ALERT SERVICE BULLETIN

ASB No. AA-03037

External Hoist Kits

This Alert Service Bulletin is being issued in response to an incidence of fatigue cracking of the fairing attachment point of P/N 206-992-110/-120 and 407-992-102 Hoist Support Assembly. This bulletin provides the procedures for inspection of the Hoist Support Assembly and identifies the appropriate modification of the part as necessary post inspection.

**FIGURE 1- HOIST SUPPORT ASSEMBLY INSPECTION**

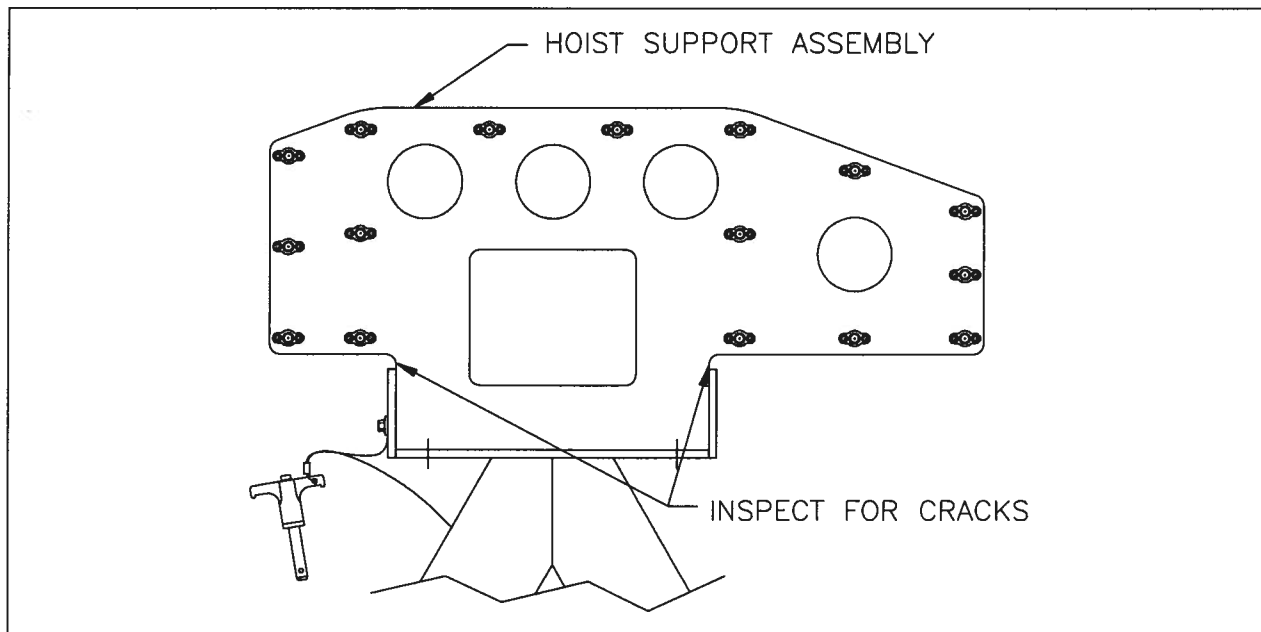
- 5.1.1 (If applicable) Remove Hoist Motor/Fairing/Support Assembly from helicopter.
- 5.1.2 (If applicable) Remove Faring halves from Hoist Motor/Support Assembly and retain hardware for later reinstallation.
- 5.1.3 (If applicable) Remove Hoist Motor from Hoist Support Assembly (P/Ns 206-992-110/-120 or 407-992-102) by removing the four ¼" bolts fastening the feet of the motor to the Hoist Support Assembly. Discard hardware. Place Hoist Motor in a secure dry place away from the work area.
- 5.1.4 Inspect Hoist Support Assembly for any sign of cracking in the plate areas directly above the weld fillet between the two small diagonal gussets and the back plate, as shown in Figure 1.

5.1.5 Determine **DAMAGE TYPE** as detailed in **Table 1 - DAMAGE AND REPAIR LIMITS** and proceed to the appropriate instructions as identified in **Section 6.0 REPAIR PROCEDURES**.
